A Repair

**ON-SITE SEWAGE DISPOSAL SYSTEM
HOWARD COUNTY HEALTH DEPARTMENT
BUREAU OF ENVIRONMENTAL HEALTH**

ADDRESS: 6635 Isle of Sky Drive PROPERTY OWNER: John Champion

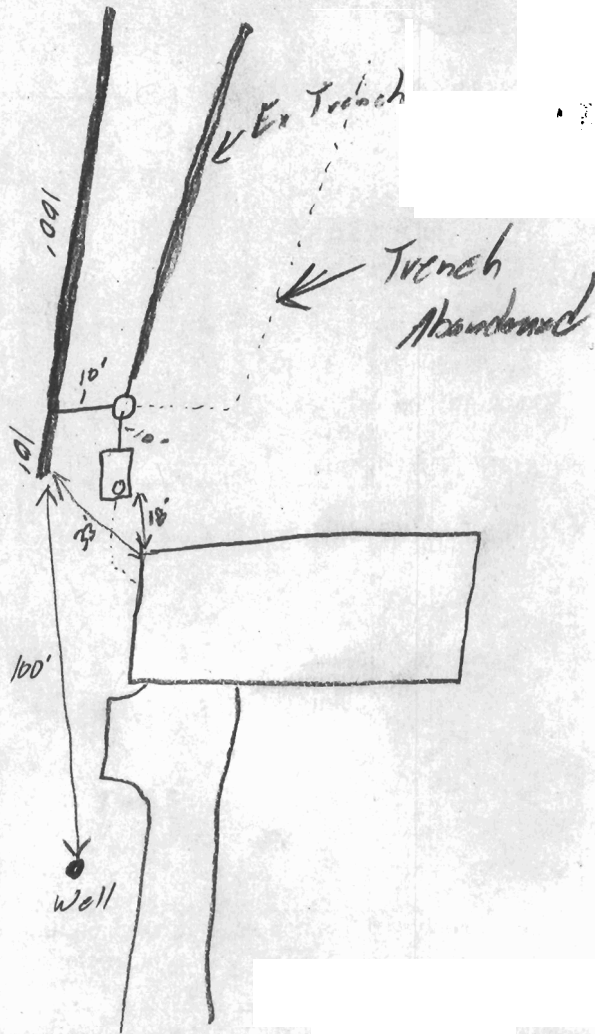
INSTALLATION 4/11/02 Cement plug place into PVC pipe in D.B. to block abandoned trench. OK to cover all work (S)
